Spinfisher 420SSG and 430SSG Bail Spring Issue

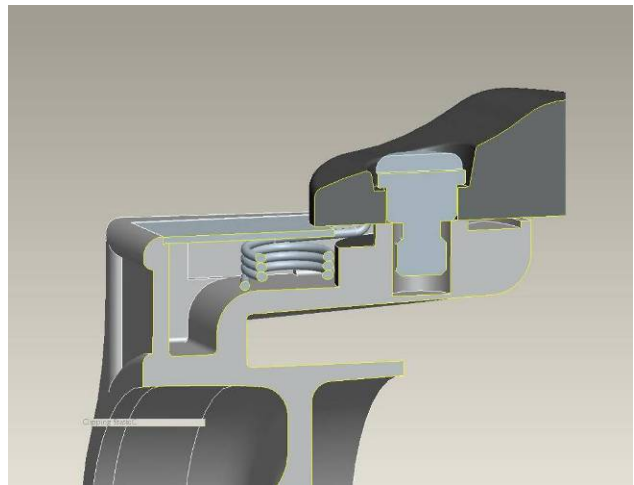
A recurring repair issue with the bail spring of the 420SSg and 430SSg Spinfisher reels has been the tendency for the torsion spring to fall out of the bail cam. This renders the bail wire and the reel useless.

Affected Reels: All Spinfisher 420SSG and 430SSG made before 6/1/2010
The rotor mold has been modified to prevent this issue on all future production.

A repair part has been created (032A420G Bail Spring Spacer) that installs in the rotor arm so that the torsion spring leg is supported and will not back out of the bail cam. The spacer fits snugly around the support post and does not need special tools or adhesive.
